MEMORANDUM

To: Planning Commission
From: Kinsey O'Shea, AICP, Town Planner *KO*
Date: December 14, 2018
Subject: RZN18-0008/ORD 1872- Request to rezone 4.215 acres from R-5 Transitional Residential zoning district to PR Planned Residential zoning district at 1222 Patrick Henry Drive (Tax Map No. 196-A 5) by Justin Boyle of Green Valley Builders, Inc. (applicant) for Gary W. Case of Acme Holdings LLC (property owner).

This staff report has been updated to reflect the revised application submitted December 3, 2018. Please see additional background below.

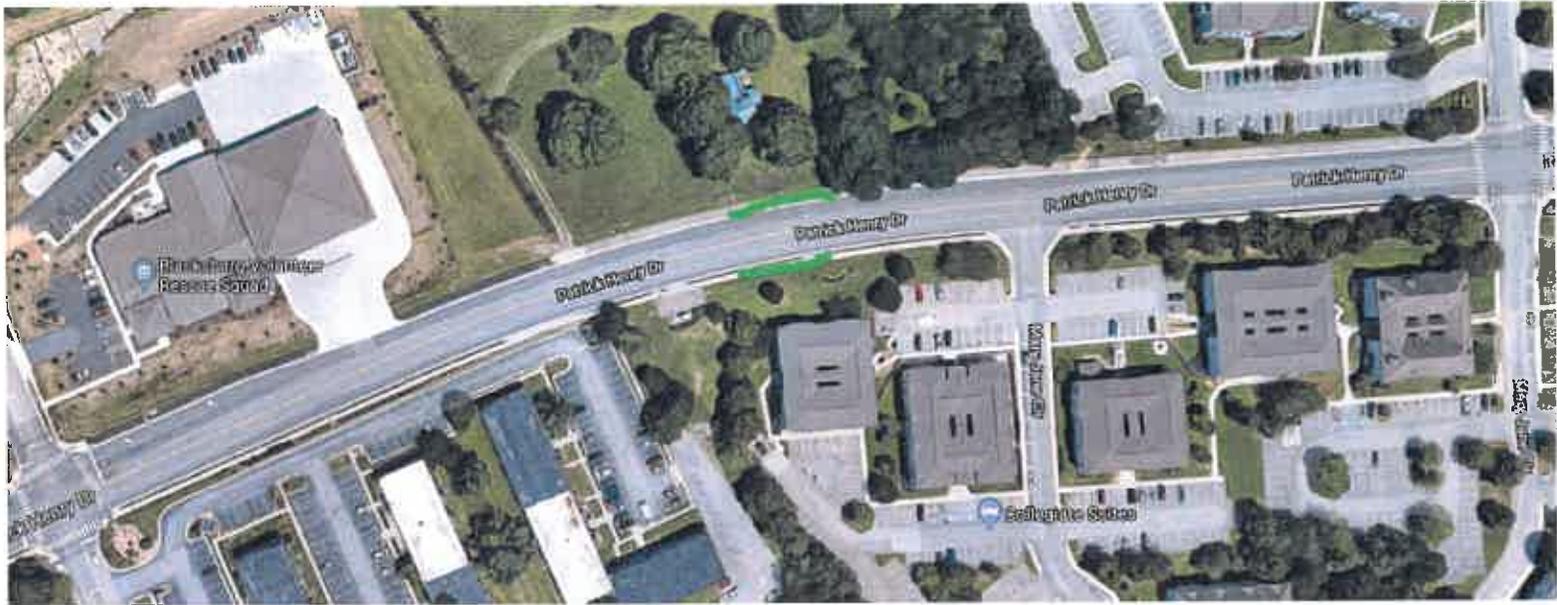
3. BT plan for handling the increase in demand for transit: BT would welcome infrastructure improvements along Patrick Henry to support additional ridership. Bus pull-offs on both sides of the street would be ideal. Pull-offs need to accommodate 60' buses; dimensions should include 65' bus bay with 50' tapers, ideally.

6. Other: Crossing the road should be discussed further. Nearby crosswalks do exist. See diagram also.

Green lines indicate desired locations for future transit bus pull offs. Each would be approximately 65' bays with 50' tapers, with bus shelters as well.
